November 21, 2024

Response to Comments

Major Subdivision – Final Plan Amendment Application Canada Hill Subdivision

Attachment 2 – 2012 Sebago Technics Plans with Cloud Notations

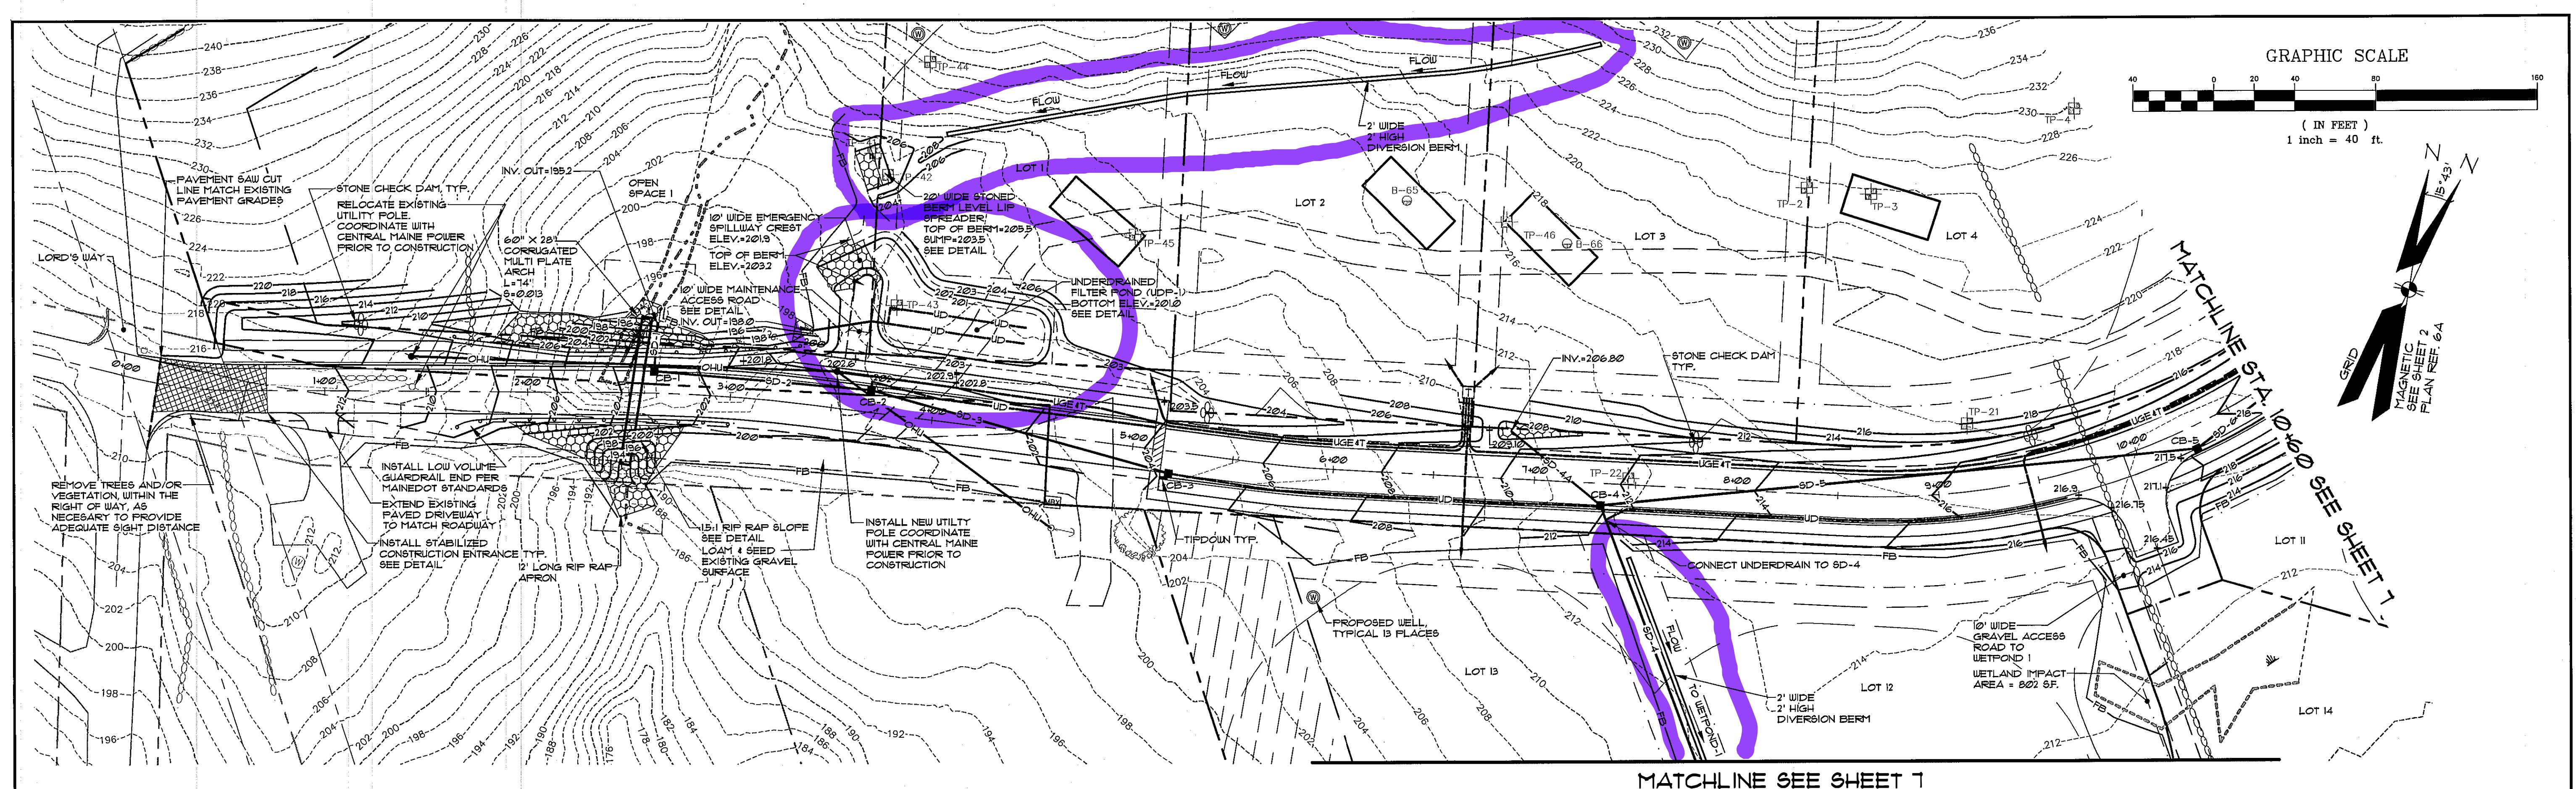
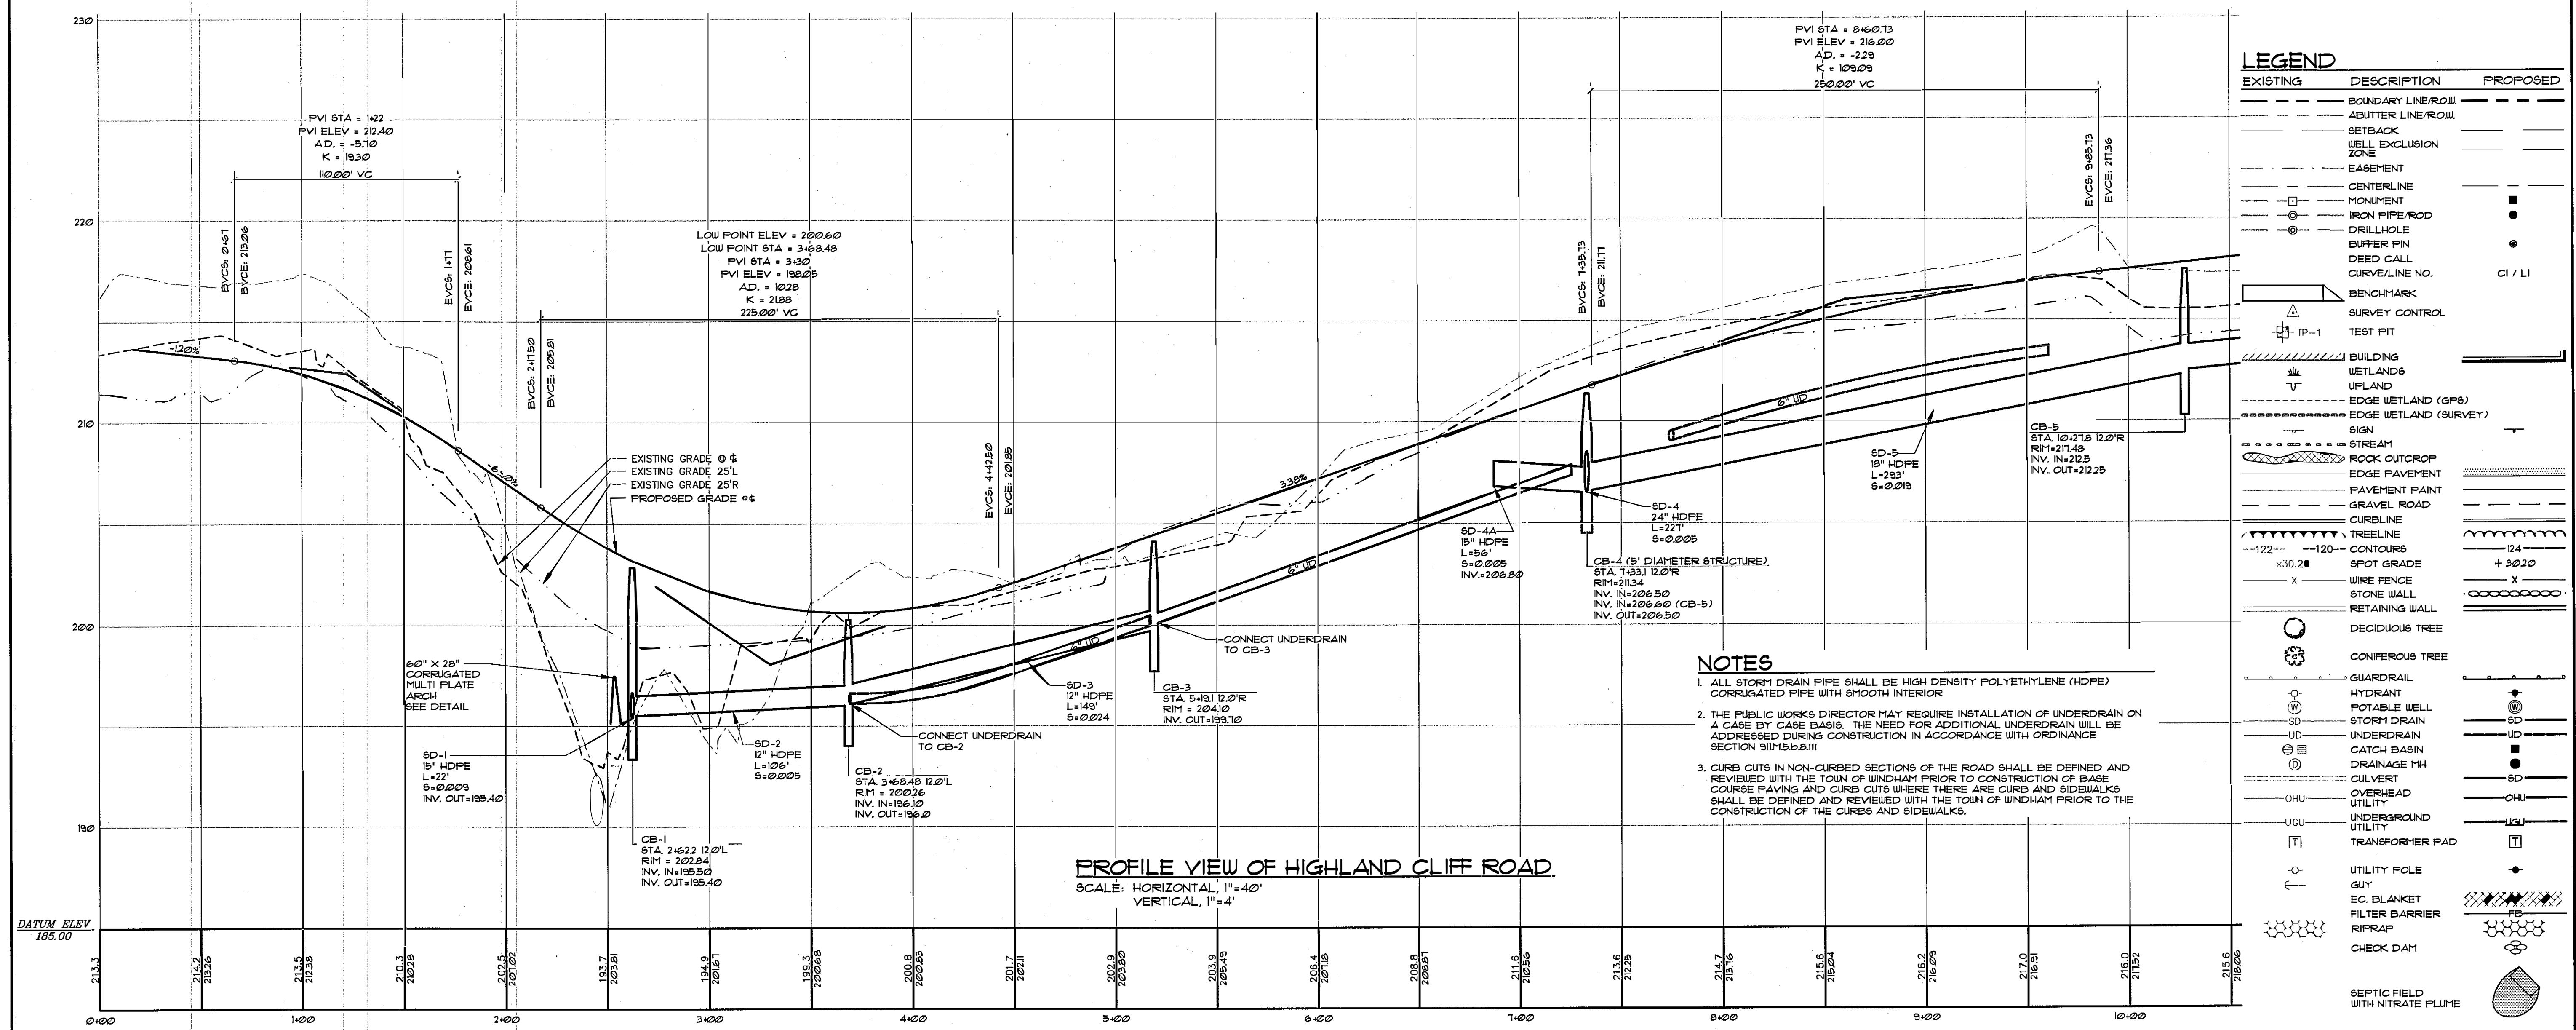
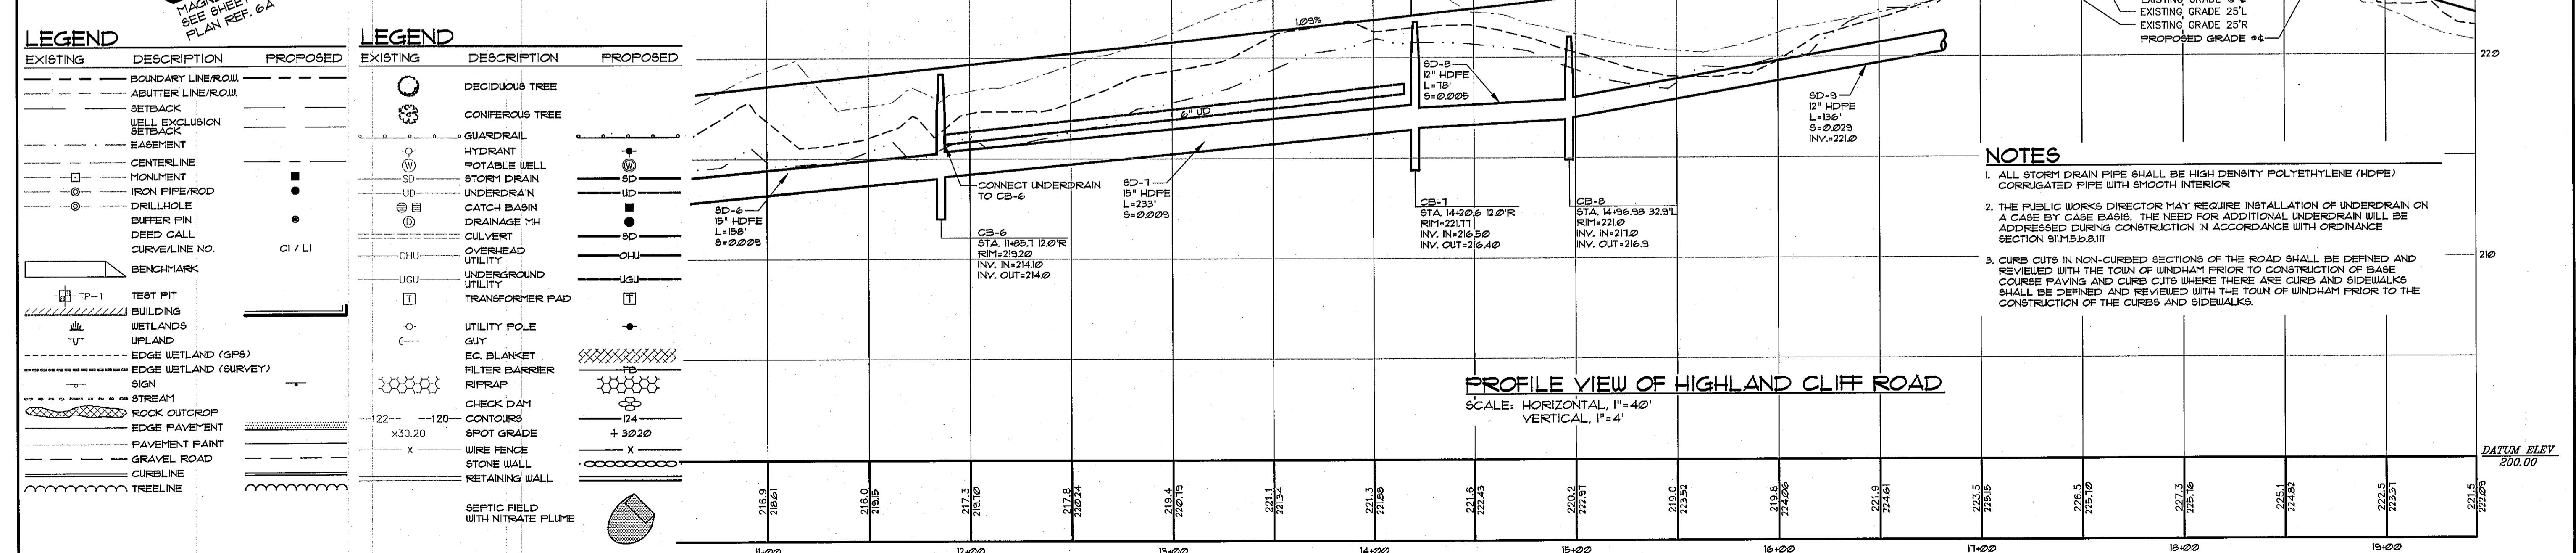
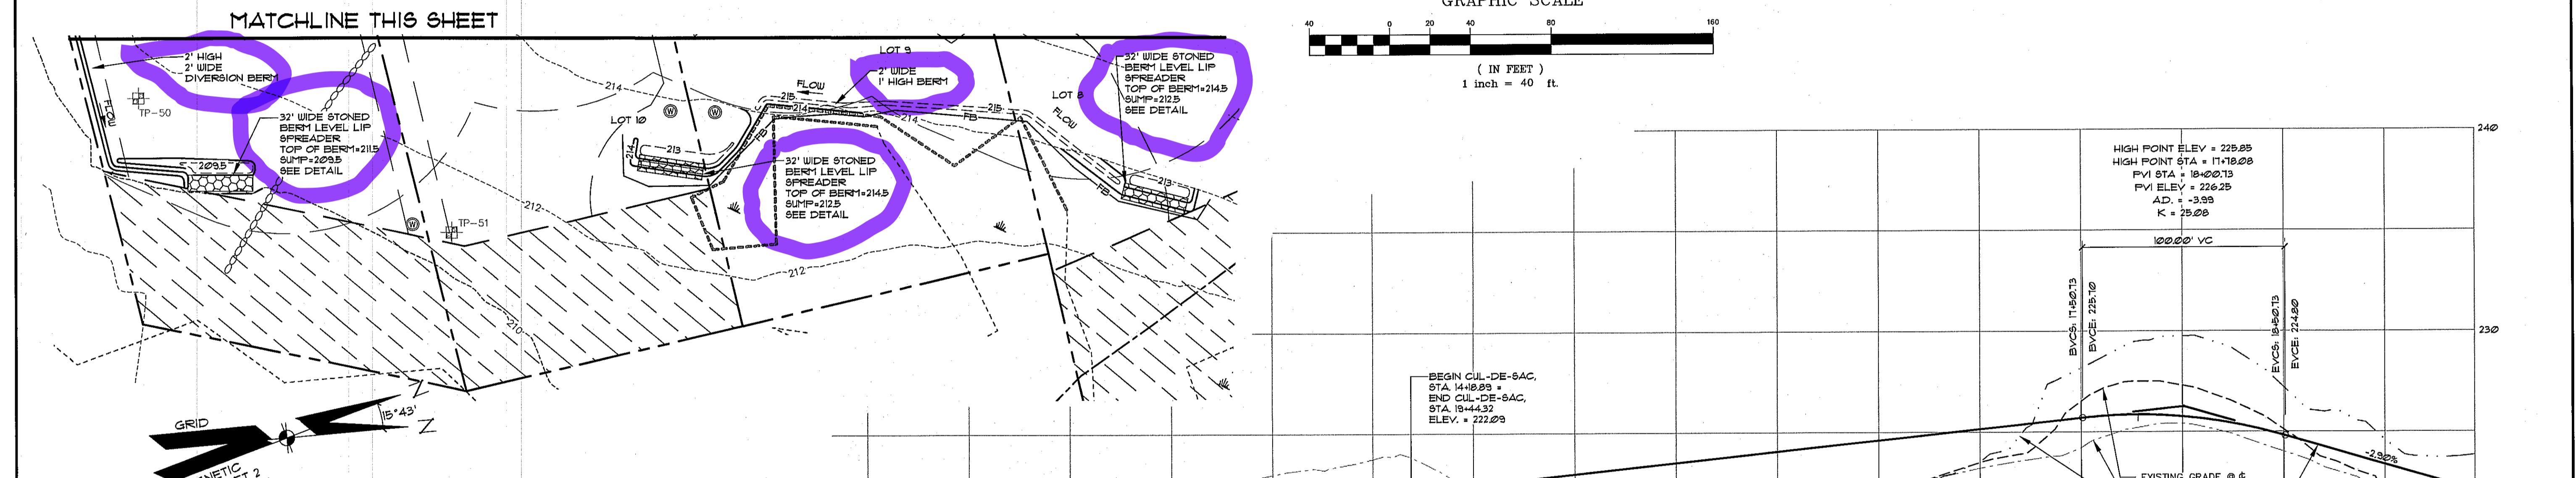
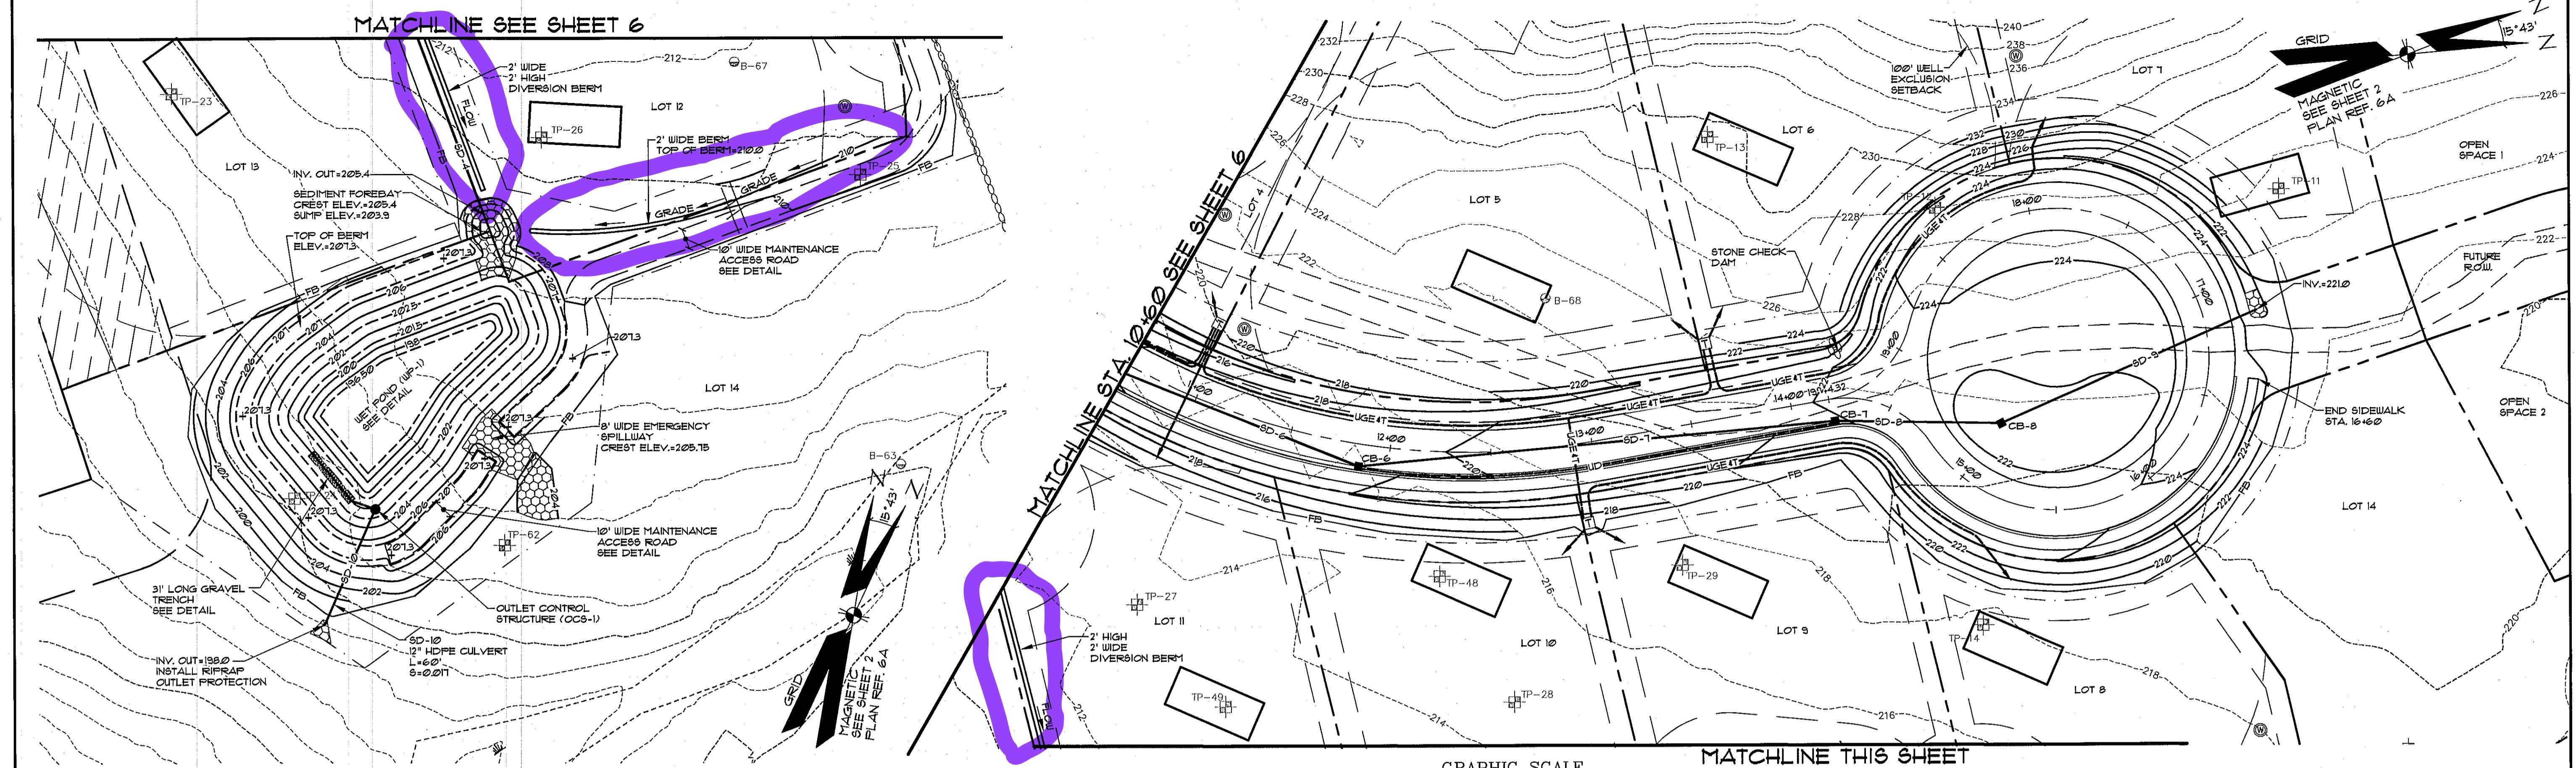
- Provide all the preliminary plan information that shows mark ups of the amendments for the Planning Board.

- There are a couple of notations on the plan set (see example below) where it says “construct”, but then there’s another note saying proposed work (not constructed). Based on some of the other explanations in the application, I think these items were not previously constructed and the Applicant doesn’t intend to construct them as part of the Phase I Plan Amendment or Phase 2 Application. The way it is presented on the plans is confusing and should be clarified.

The punch list of items includes the construction of stormwater BMPs that were included on the 2012 Sebago Technics plans but were not constructed and modification to an existing MeDEP UDSF. The punch list of items to be constructed are detailed on the Terradyn plan set and are identified with cloud notations. For comparison purposes, Terradyn has provided cloud notations on the 2012 Sebago Technics plans for the stormwater BMPs that were not constructed. See 2012 Sebago Technics plans included in Attachment 2.

Response: The plans have been revised to remove notations for “proposed work (not constructed)” for Phase I stormwater BMPs not constructed as part of the 2012 Site Plan approval that will be constructed as part of this project and provided notations for Phase I stormwater BMPs not constructed as part of the 2012 Site Plan approval that will not be constructed as part of this project. These stormwater BMPs that will not be constructed include two (2) diversion berms and three (3) levels lip spreaders that were not constructed prior to Phase I Lots 8, 9, 10, & 11 being sold.
